UCO/Lick APF

IceStorm Enclosure (Series 2)

Lick APF Site Inspection Report

6 June 2007

Figure 5 Exert from door drawing – Calls out dead bolt as “Door Hurricane Bolt”

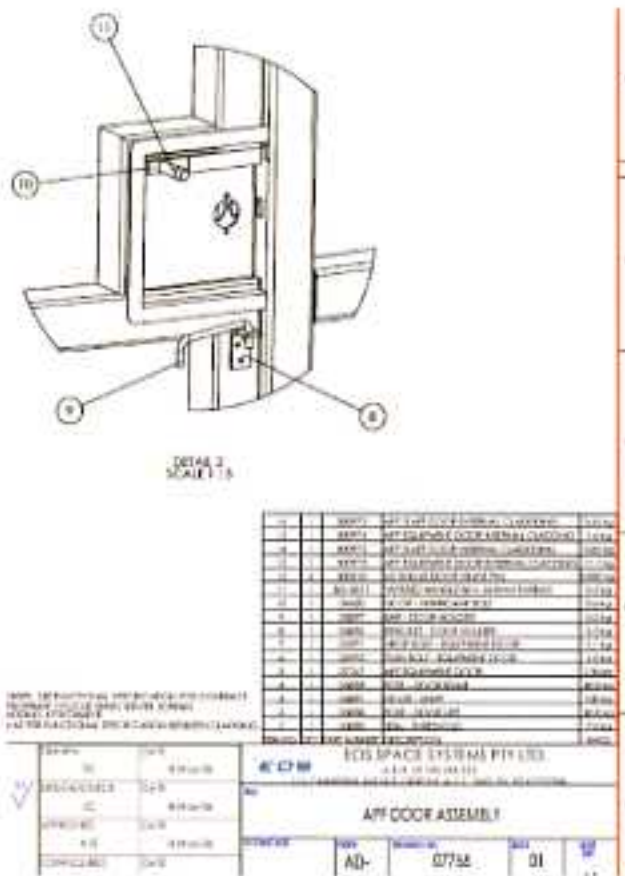
UCO-Lick claimed a safety hazard was imposed by the exterior deadbolt system on the staff entry door. The claim was made that someone could be trapped inside the enclosure if the bolt was utilised. UCO-Lick appeared to be under the impression the deadbolt was temporary.

The deadbolt existed as a precautionary lock during extreme survival conditions, to avoid the door latch being the only part preventing the staff door from being sucked open. The deadbolt has always been part of an IceStorm design, it is present at the Mt Stromlo facility and appeared on design review models.

EOS does not consider this as a design flaw or safety risk and proposes no further action is required. However, for the abundance of caution, if UCO-Lick deem this to be an unacceptable risk, then we propose to cut off the deadbolt tang to render the deadbolt inoperable.

Figure 6 Shutter control panel

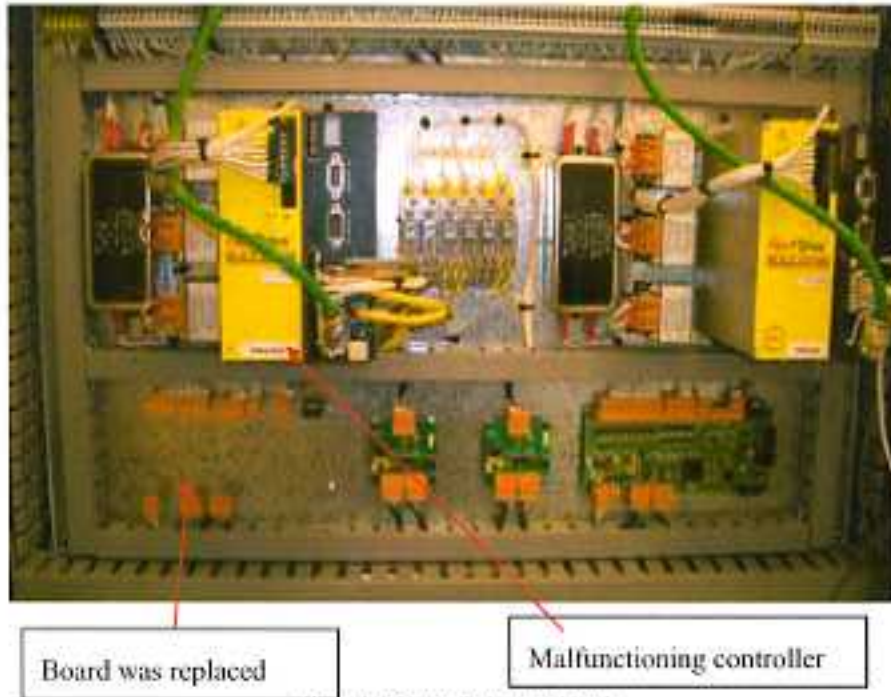
UCO tried to operate the front shutter after a period of high rainfall. The shutter would not operate and a preliminary investigation showed potential damage to a printed circuit board directly linked to front shutter operation.

The control cabinet has obvious signs of water ingress, which seems the most likely cause of shutter parts malfunction or failure. The water has apparently made its way into the control cabinet from upper levels of the enclosure. During installation, EOS installed expansion foam on the top of the cabinet to control moisture ingress (water and humidity) to the control cabinets. On inspection this was no longer present.

Further investigation by Jason Chapman and Steve Vogt indicated that the front shutter controller / amplifier was not communicating with the rest of the control systems. After a phone conversation with the EOS electrical group the decision was made to remove the amplifier and return it to Australia for assessment.

Figure 7 Longitudinal seal blade tape, preventing seal flap snags on blade ends.

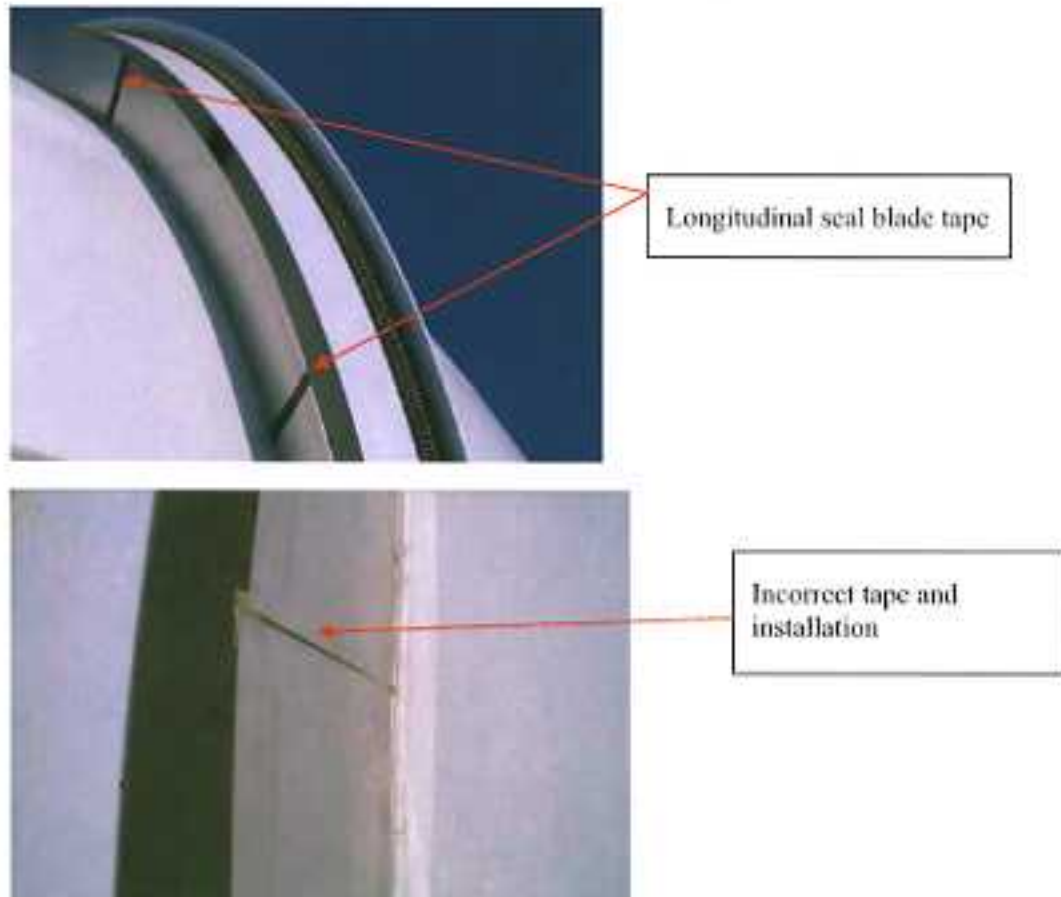
UCO noted that a tape installed on the longitudinal seal blade was falling away.

Further investigation by Jason Chapman and Matt Radovan showed the tape on the seal blade was not the correct tape specified by EOS. It was also noted that it was installed in incorrect positions and was probably installed on stainless steel blades that were not cleaned sufficiently prior to installation of the tape.

New tape will have to be installed after the trough re-caulking procedure has been completed. When re-installing the seal blades, they will be required to properly install the correct tape. EOS can provide instruction on this.

Figure 8 Longitudinal seal flaps.

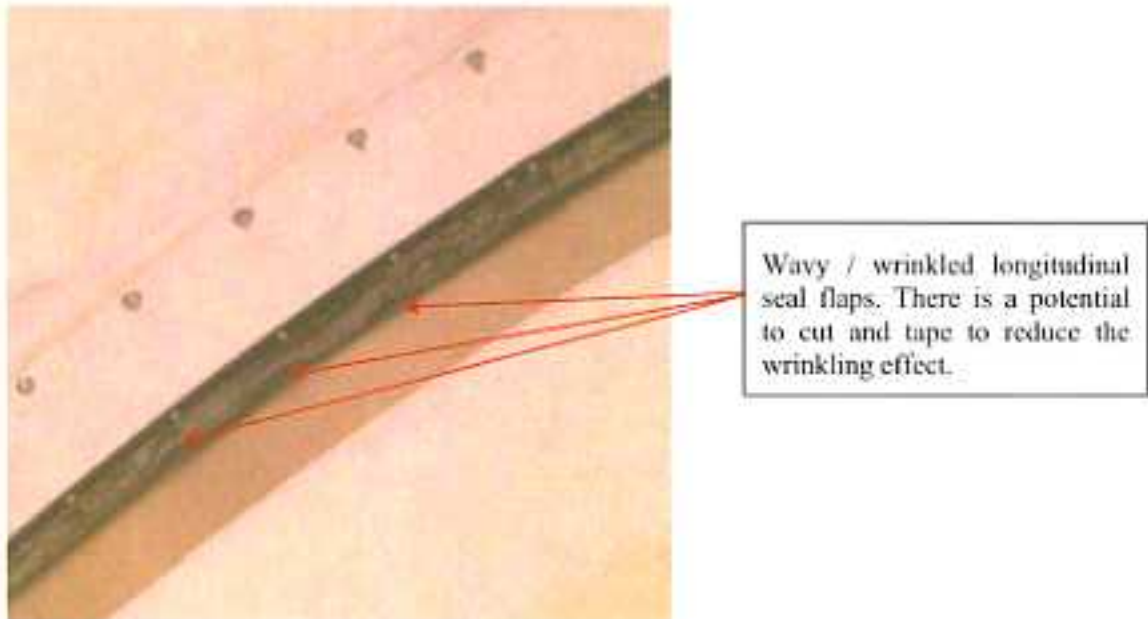
UCO-Lick has stated that the shutter longitudinal seals flaps are not sealing appropriately due to wrinkling.

These longitudinal seal flaps are installed to prevent significant light leaks and to minimise air flow between the exterior atmosphere and the enclosure interior. No light leaks were observable along these seal flaps. It is not easily determined if the seal flaps would improve air leakage significantly if they had 100% contact along their length.

As no moisture is infiltrating at these points EOS has determined the seal positions and function as acceptable, and replacement of the seals is not necessary.

At UCO-Lick's discretion, the seal flaps may be relieved to reduce wrinkling, with cutting then taping (with UHMWPE tape) between joins by UCO or WPY during the re-caulking project.

Figure 9 Air gap present in pier seal.

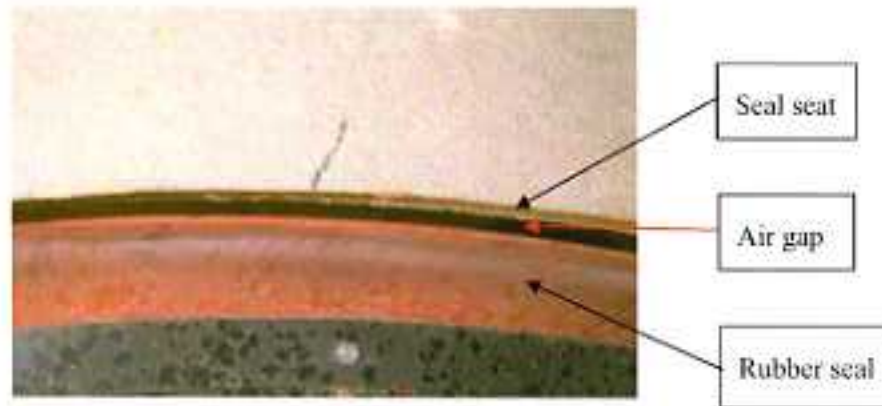
UCO-Lick observed a source of light leak from Level 1 to Level 2 during night hours, when Level 1 lights are switched on and the observing space is in darkness. The leak was traced to the seal that runs around the telescope base.

It appeared that there is a significant gap were the silicone rubber seal flap should run on a stainless steel pier seal seat.

The problem appears to stem from straight strips of rubber being bent on a tight radius to form the seal flap. The radius is seemingly too tight and the rubber folds back on itself without touching the seal seat.

EOS will test some different rubber configurations to find the pattern that works best. Cut rubber could be sent to UCO-Lick to install and alleviate the problem.

Figure 10 Shutter cable entry bulkhead / panel

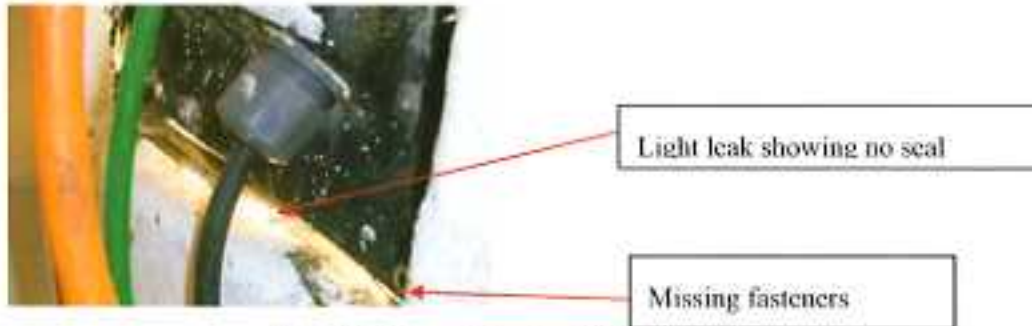
UCO-Lick expressed dissatisfaction with the installation method of the shutter cables entry bulkhead, located on the inside of the troughs. There is no evidence of seal gaskets and 2/3rds of the attachment studs are missing nuts.

This was observed as being a valid assessment by Jason Chapman. Light leaks were prevalent around the bulkhead.

EOS will fabricate and deliver 2 x closed cell foam gaskets and a bag of fasteners to UCO Lick for installation onto the gland plate.

Figure 11 Different cladding on the entrance door and ring wall.

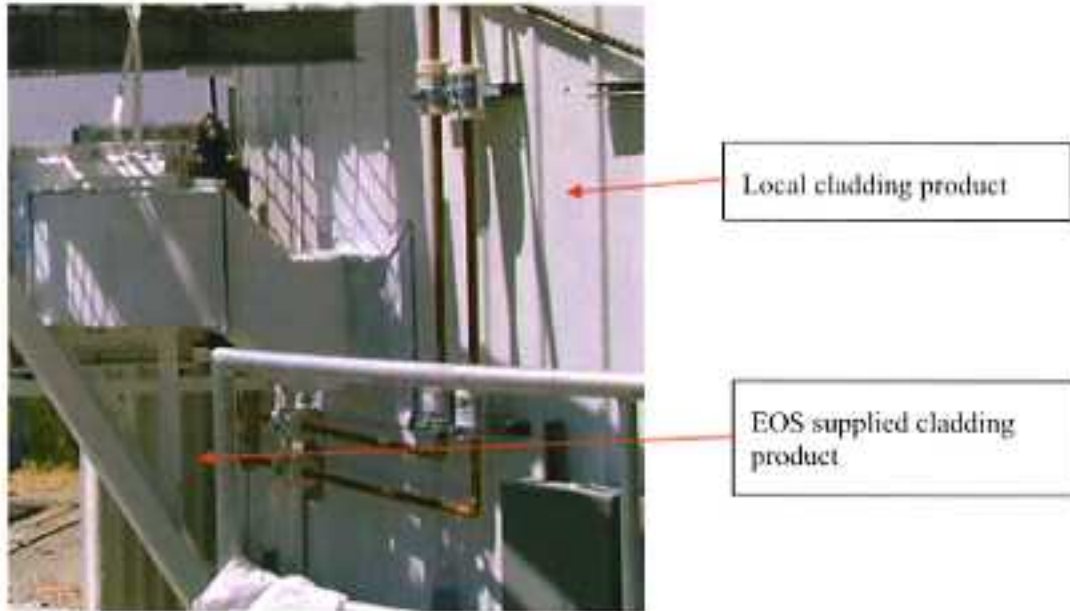
UCO-Lick noted that during the assembly there were problems with steel ring wall cladding supply. Locally sourced cladding was required to finish the enclosure.

The EOS supplied cladding profile differed to the locally sourced cladding profile, although the colour is a close match. When the ring wall was clad, the entry doors were left the same as they were fabricated with correctly installed cladding.

EOS does not consider the cladding profile difference to be a function, design or other issue and in fact enhances safety as it acts as a tactile indicator of reaching the door when lights are extinguished in the enclosure.

The cladding on the door has been sealed with closed cell foam that conforms to the EOS supplied cladding profile. The advantages of keeping the supplied cladding profile outweigh any visual effect from replacing it.

Figure 13 Shutter rail - Shutter flares installed to these

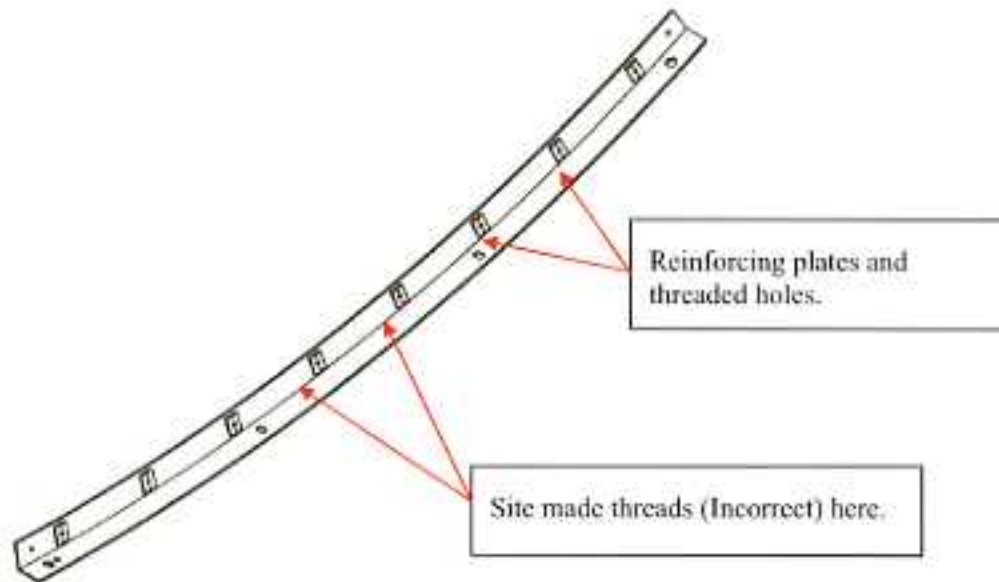
UCO-Lick raised an incorrect fit of shutter flares to Jason Chapman. Several of the (cosmetic) flares, which are attached to aluminium rails by screws, appear to missed the intended threaded hole and backing plate, and were screwed directly to un-reinforced aluminium rails.

UCO-Lick would like assurances that the incorrect installation still meets survival conditions.

EOS will calculate the effect of the as built installation and email our findings to UCO. If the flares do not meet specification, rectification will require holes in the flares to be re-drilled and fasteners installed to the correct threaded holes. Old holes can be plugged (white plastic plugs) closed. As the flares are cosmetic covers for drive gear, the standard of weather sealing does not matter.

Any rectification must be completed when a boom lift (Elevated work platform) is on site. It would be ideal to do this during the re-caulk exercise. Calculations will be made as soon as possible.

Figure 14 General example of trough sealing quality

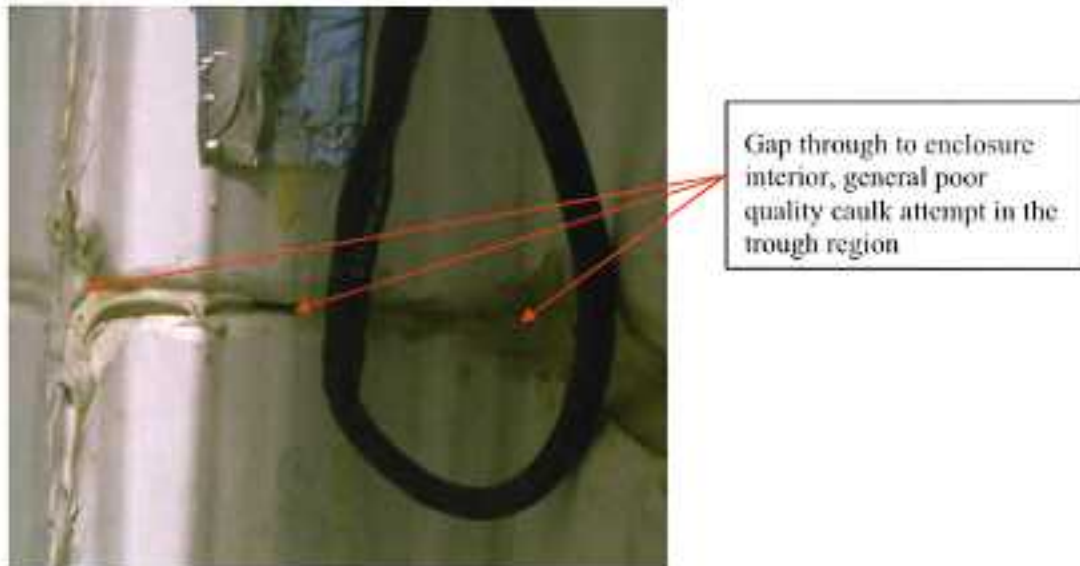
UCO-Lick has indicated water ingress coming from the region of the shutter chain troughs. Claims had been made by UCO-Lick and WPY that the design of the troughs was such that sealing was impossible due to large gaps between troughs.

Upon inspection by Jason Chapman and Matt Radovan (with Steve Vogt in attendance), it was determined that the joins were in fact sealable, or within acceptable tolerance ranges allowing sealing to occur, but the caulking by WPY contractors was poor.

Large pockets and gaps were easily distinguishable in most of the joints reviewed. All of these flaws would cause serious leaks, especially as the troughs act as a gutter during periods of precipitation. High flows of water would be prevalent in these areas.

EOS will provide a procedure to re-caulk the enclosure infills and troughs, which will attempt to eliminate the need to remove the shutters from the enclosure.

Figure 15 Skirt attachment screw

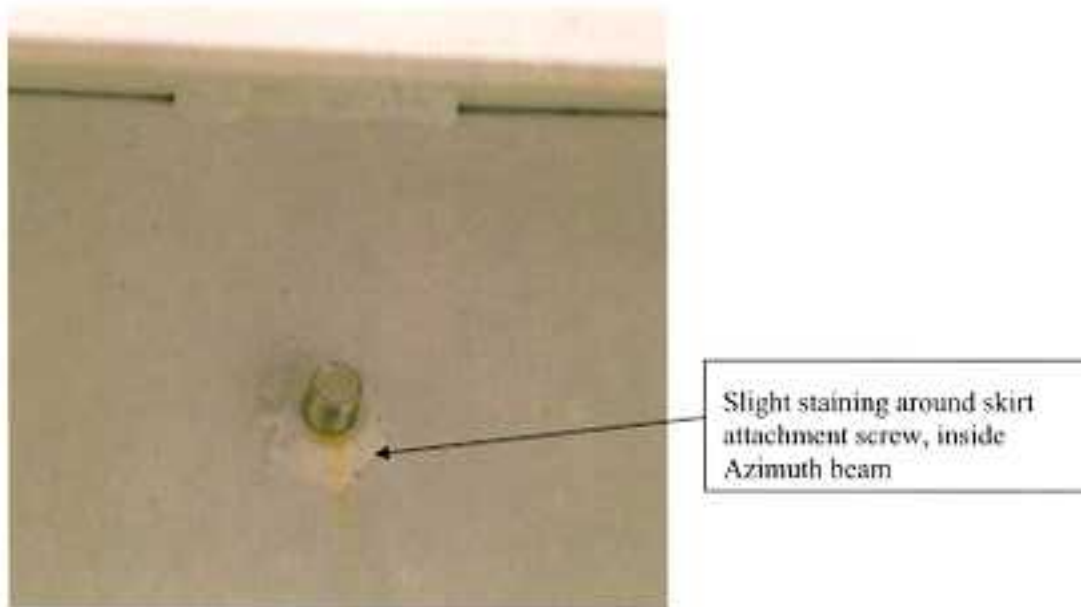
UCO-Lick incorrectly identified leaks as originating from the Vent Door Lower Rail Bolt Heads. Some slight discoloration is shown in the inside of the skirt attachment screws, inside the Azimuth support beam.

This discoloration is slight and Jason Chapman could not see any evidence of significant leaks, the discoloration may be caused by condensation after assembly, when the enclosure was still open to the elements. The position of the screws suggests it would be very difficult for water to make its way inside the enclosure from these points.

Figure 16 Shutter bolt leak

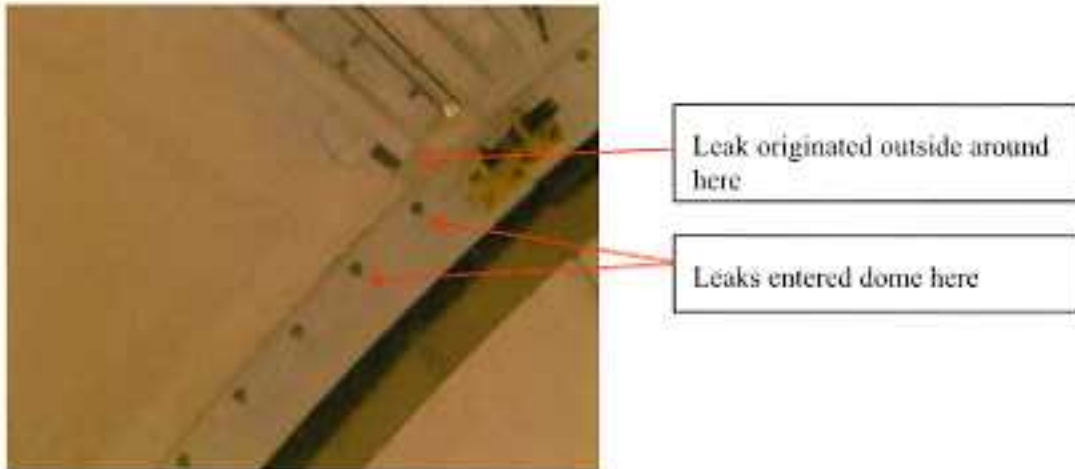
UCO-Lick found water dripping from 2 bolts on the upper right hand side of the front shutter, after a period of rain. An *assumption* was made that water had made its way into the enclosure via flare attachment points.

After investigation and suggestions by Jason to pour water on the shutter transverse gutter, the leak point was identified as a hole in the caulking, under the upper right hand side of the top transverse beam. Water channelled between an interior seal, until it reached the through-bolt connections and ran into the enclosure.

EOS suggests that UCO or WPY staff fill the hole with caulk during the shutter trough re-caulk project.

Figure 17 Shutter butt joint light leak

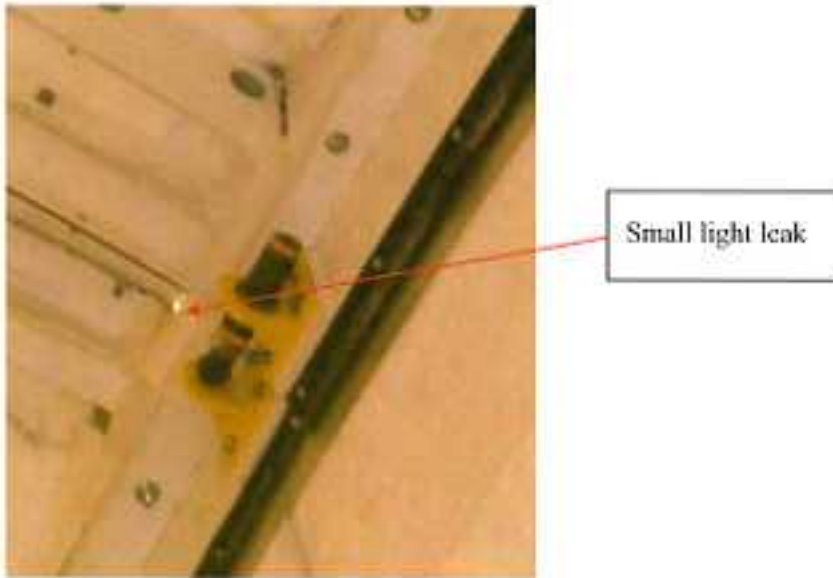
UCO-Lick identified a light leak, but no mention was made of a water leak at this point.

UCO-Lick staff (Matt Radovan) could not put his finger through the hole from the enclosure exterior, due to the geometry of the shutter fibreglass and frame.

For water to ingress at this point, it would have to travel through a series of fibreglass overhangs, and be blown up-hill.

EOS response is that this claimed leak is not in fact an issue, as no evidence of water, or the ability for water to enter here exists. UCO-Lick can adapt the shutter if they wish to try and reduce the small amount of light leakage.

Figure 19 Snow melt cables

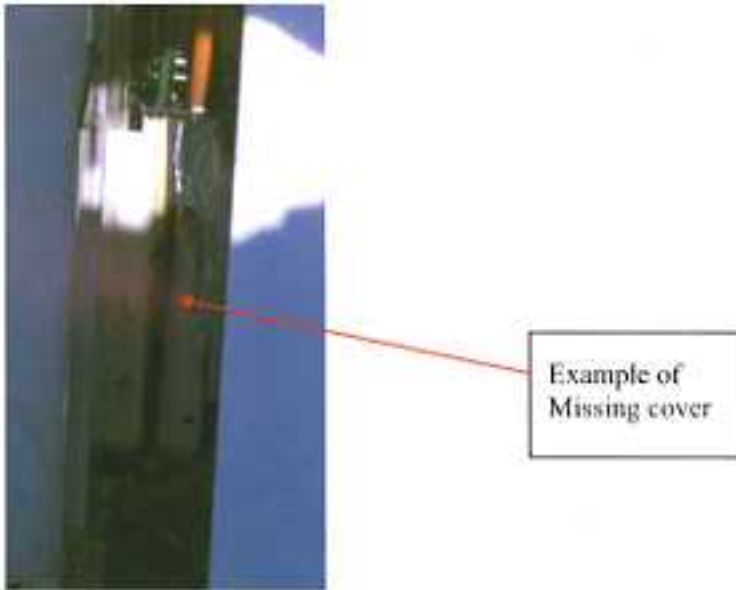
It was observed by Jason Chapman that the snow melt cables were in a dangerous state, missing mechanical protection in the shutter trough. The shutter cable chain could eventually wear through the insulation and the potential for electrical fault is high.

All cable covers were supplied on site. The particular cover missing would have to be trimmed in situation. WPY would have been responsible for this work as part of the enclosure build.

EOS will re-supply the missing cover. WPY should install the cover correctly during the trough re-caulk work.

UCO-Lick were instructed verbally not to operate the shutter system unless under extreme caution and at their own risk.
